SNOWDON RESIDENCE

2711 BRENTWOOD ROAD
BEXLEY, OHIO 43209

BEXLEY ARCHITECTURAL REVIEW BOARD PACKET
LAST REVISED: OCTOBER 12, 2023

Comments from the Board at the September meeting focused on the following items:

UPDATED PER COMMENTS FROM SEPTEMBER ARB

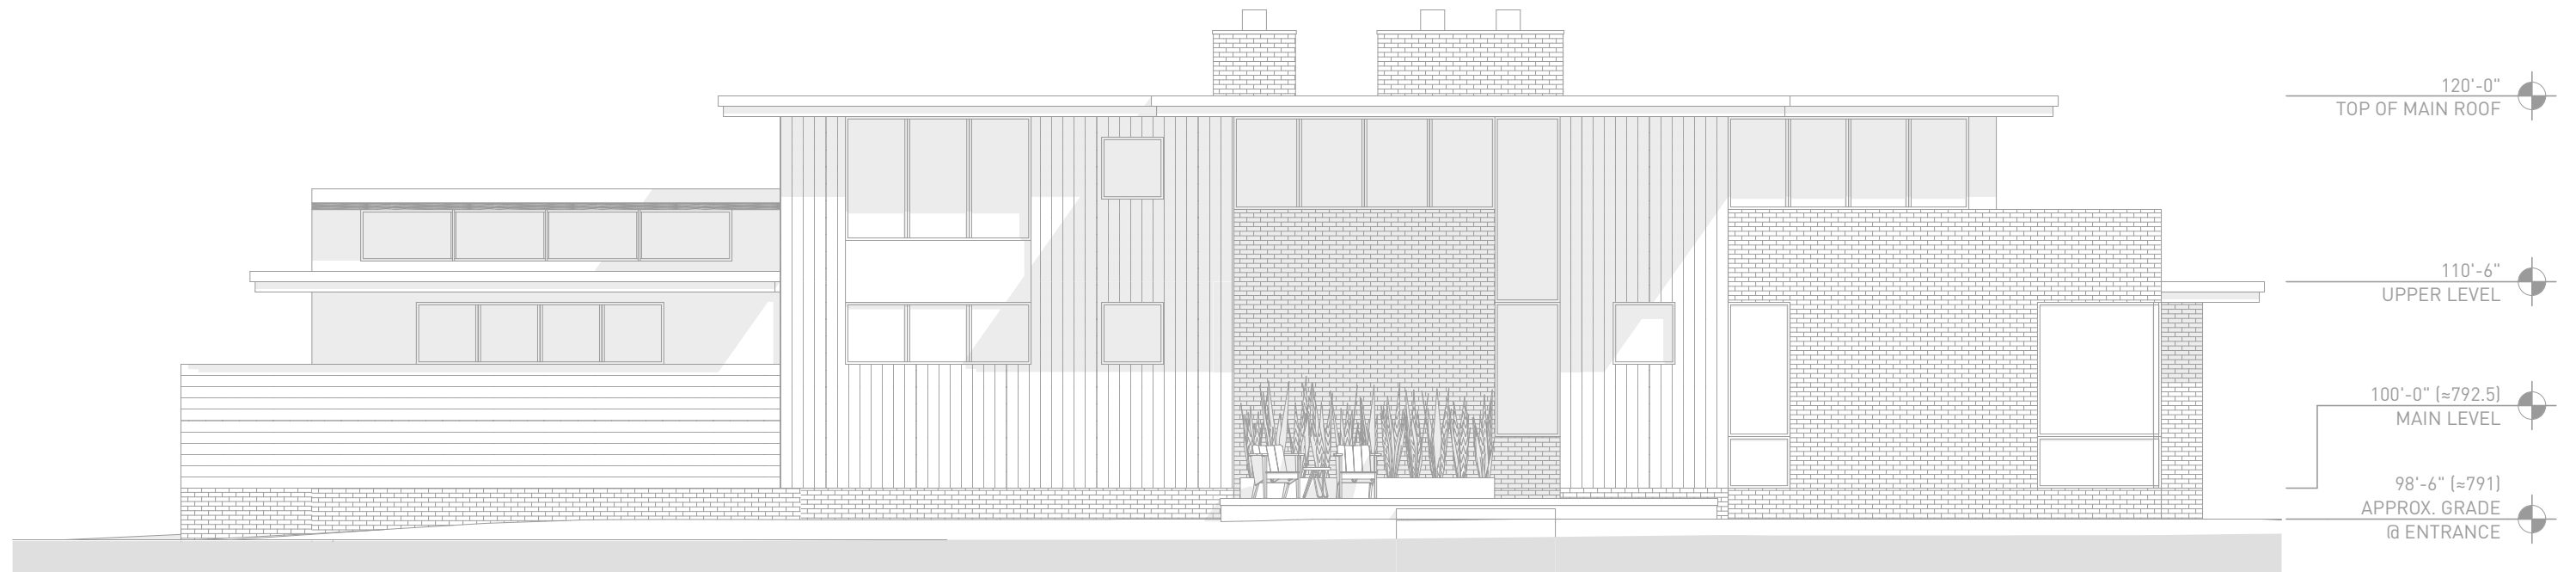
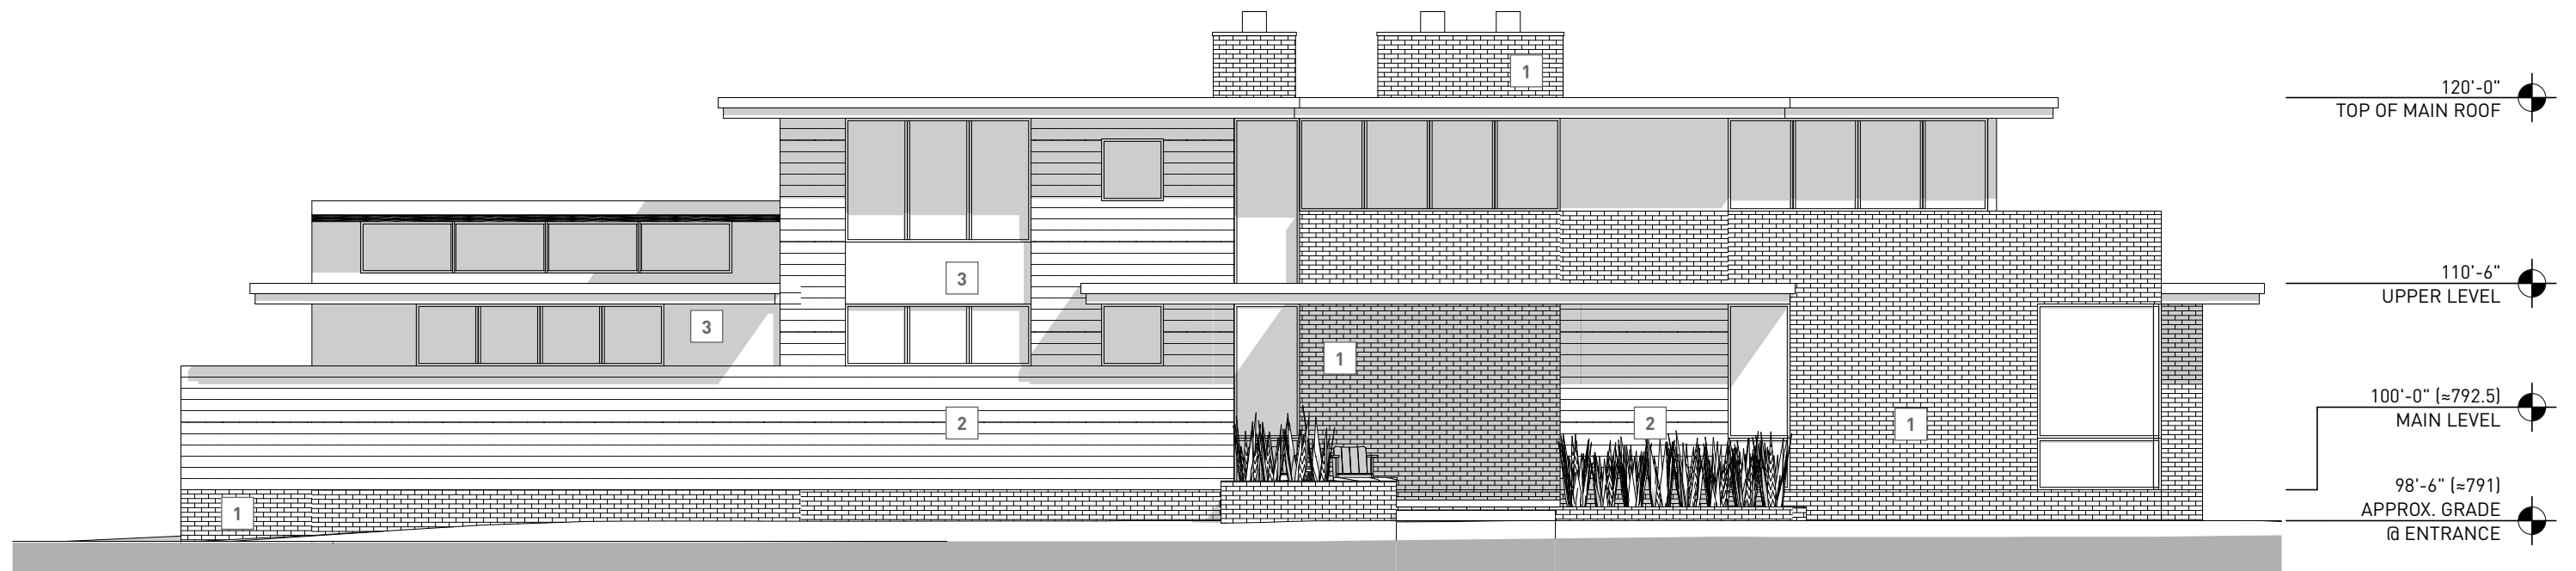
The scale of the front porch – lacked a human scale.

Front porch roof was reworked. Upper roof became secondary, and a new lower roof was added to reduce the scale of the porch and enhance the usability. Entry element was reduced from double height to single. Symmetry of the porch overall was reduced. Also added a low planter/bench wall to help better define the porch and reiterate the scale of human occupancy.

UPDATED PER COMMENTS FROM SEPTEMBER ARB

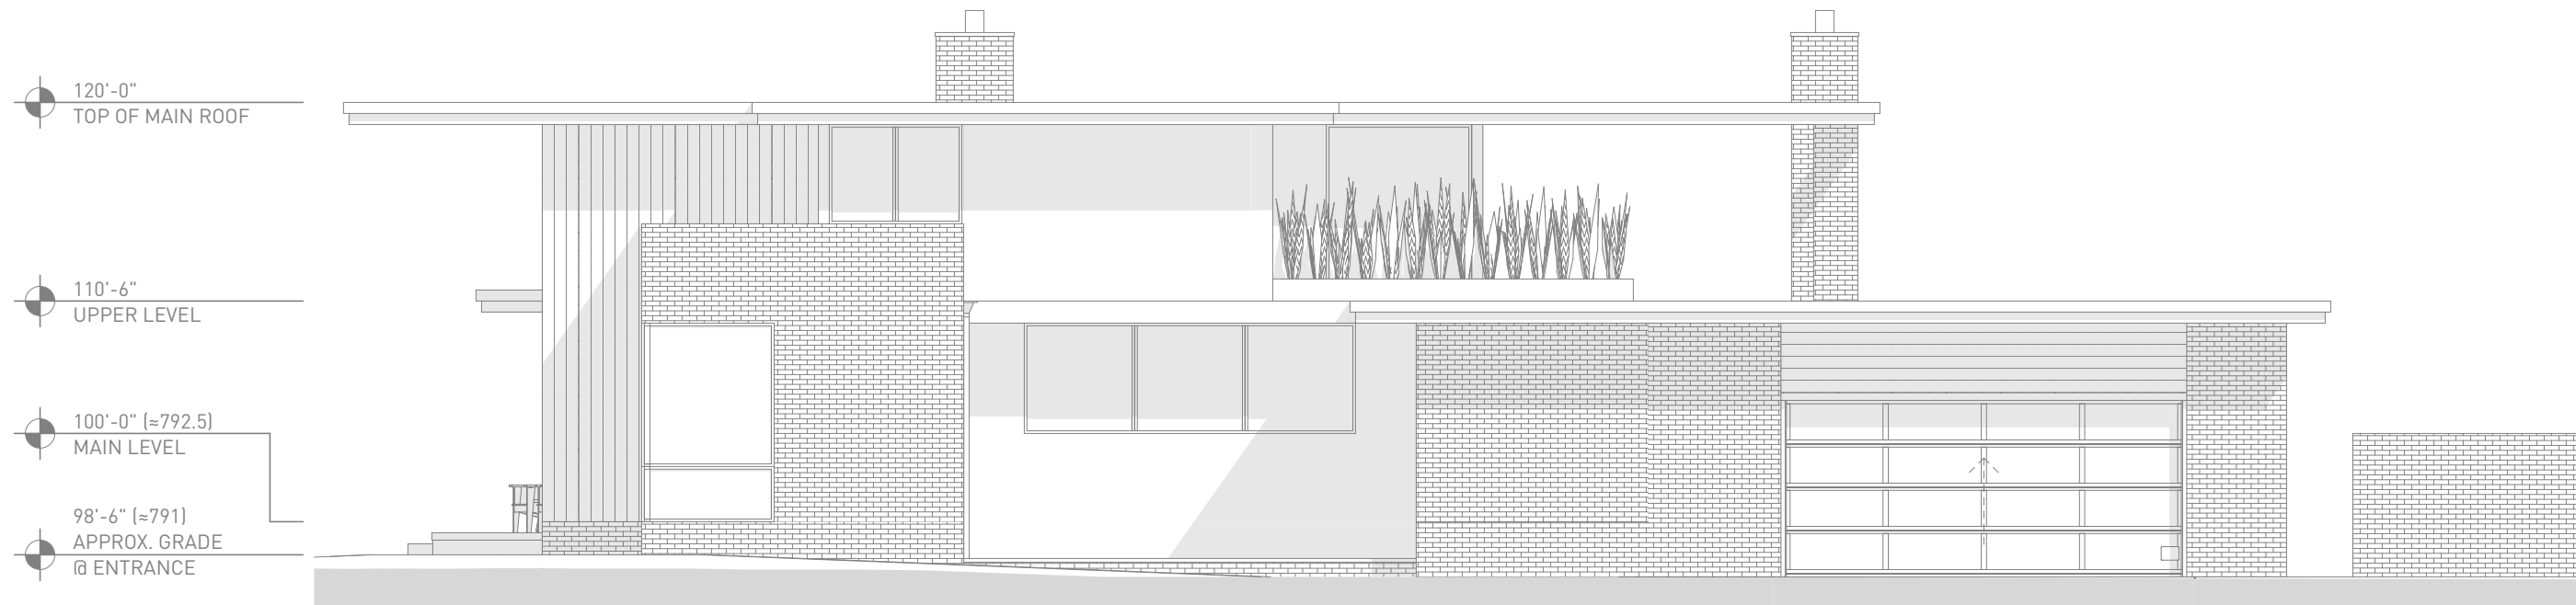
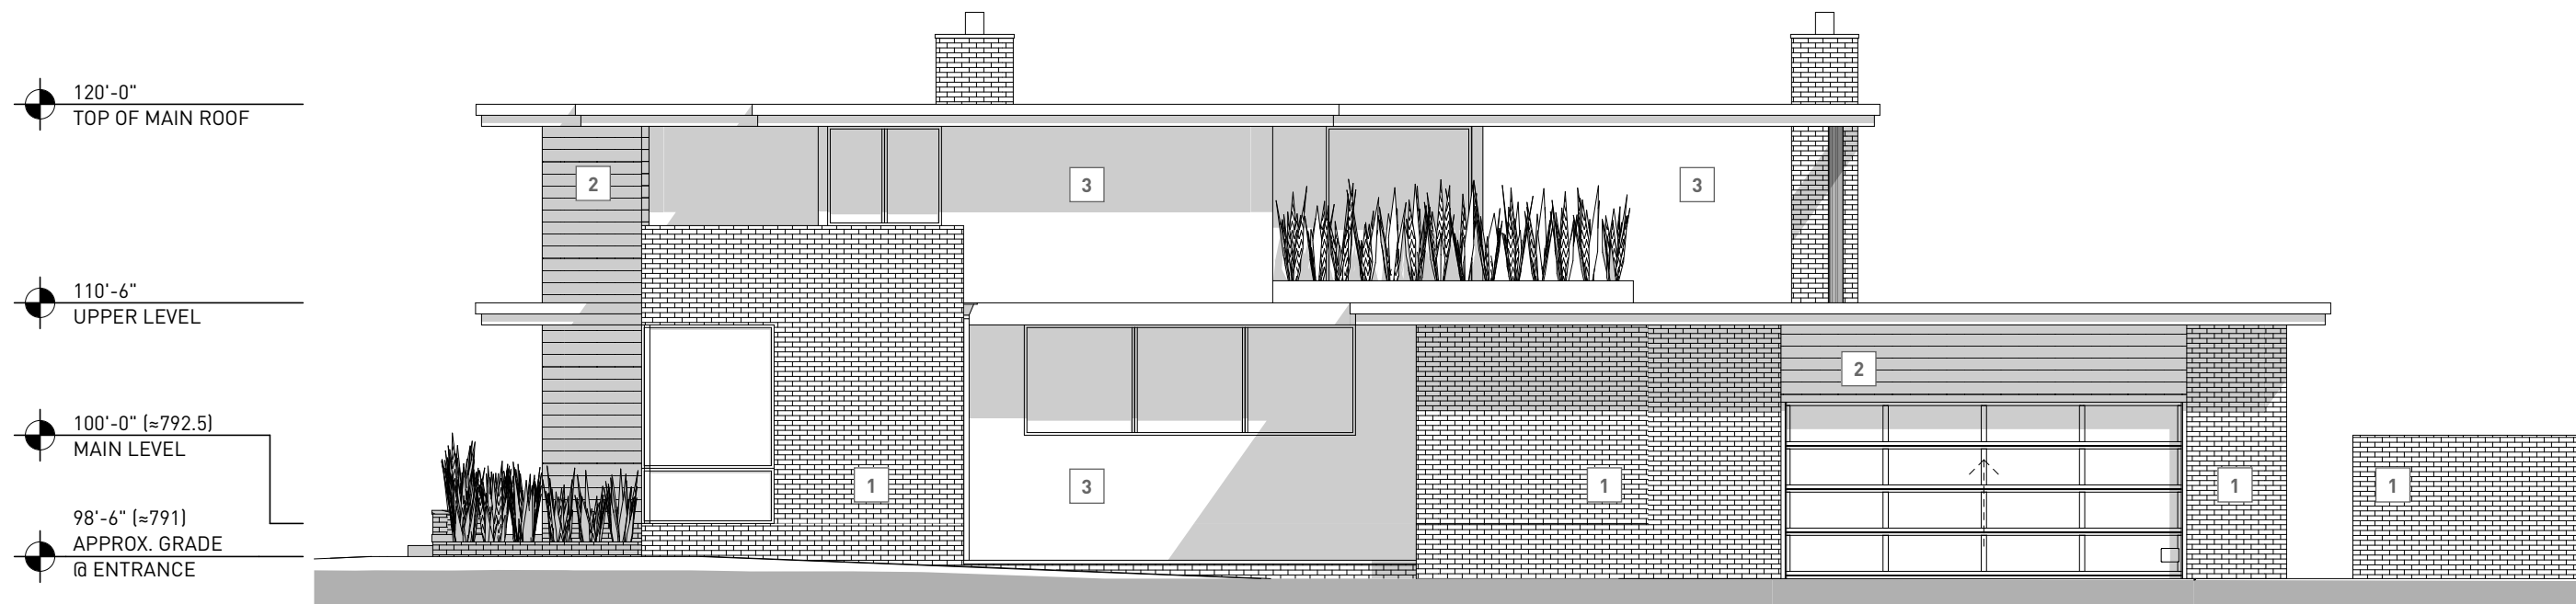
Siding – some members expressed concern about the multiple orientations of the siding on the front of the house.

Additional study of the wood siding was conducted and ultimately the decision was made to unify it by running it all horizontally. In addition to creating a more unified and visually calmer appearance, the horizontal also again registers the human scale.
